InfiniBand Network Architecture

Last updated on: September 1, 2004

InfiniBand Network Architecture, First Edition Errata

Figure 1: The Register Region Verb Call

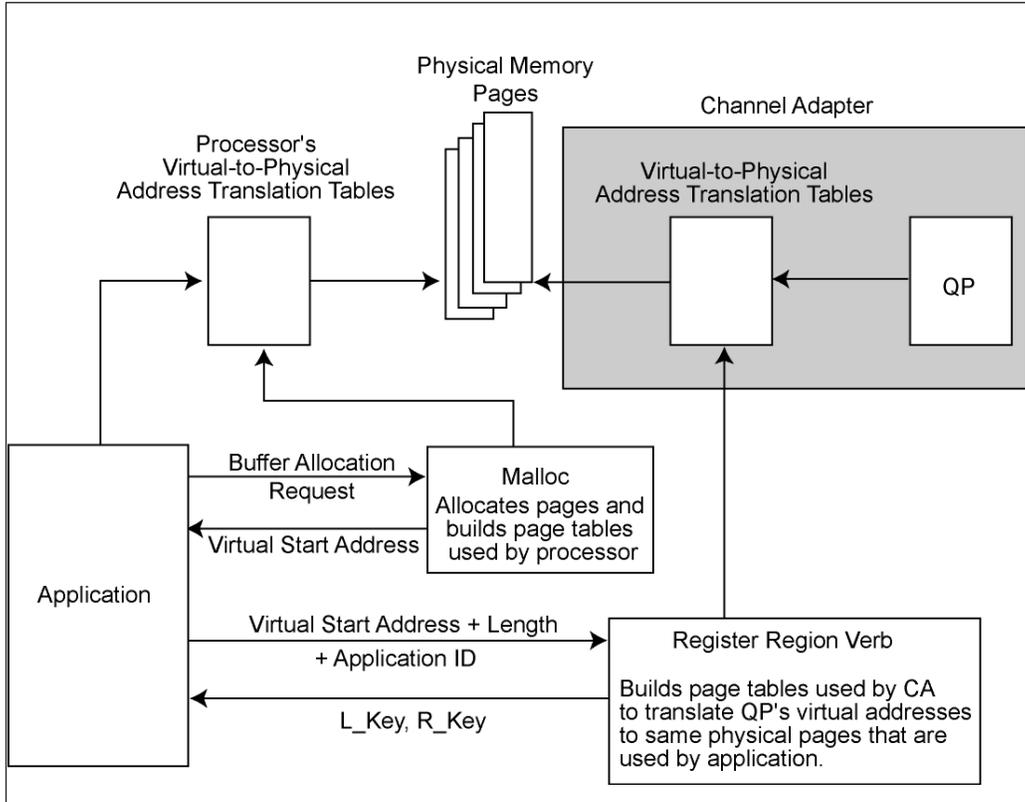
Page	Severity	Date	Description
301	important	9/1/04	Refer to Figure 1 on page 9. Replace the numbered list with the following: 1. The application calls the OS malloc routine with a request to allocate a buffer within the application's memory space. 2. The malloc routine locates a series of physical pages in memory that are available and provide at least the requested amount of memory. 3. The malloc routine creates a series of page table entries that map the application accesses within its virtual space to the physical pages in memory. 4. Malloc returns control to the application. 5. The application executes the *Register Memory Region* verb to create a region of memory that can be accessed by the QP(s) the application uses to send and receive messages. It supplies the start virtual address and length of the region, as well as the ID of the calling application. 6. Using the application's ID and supplied virtual address range, the *Register Memory Region* verb obtains the list of physical pages that are mapped into the application's virtual buffer space. 7. The verb creates a page table within the HCA that maps the same virtual buffer address space into the same physical memory pages. 8. The verb returns control to the calling application, supplying it with a local access key (L_Key) and, if remote access rights were requested, a remote access key (R_Key).
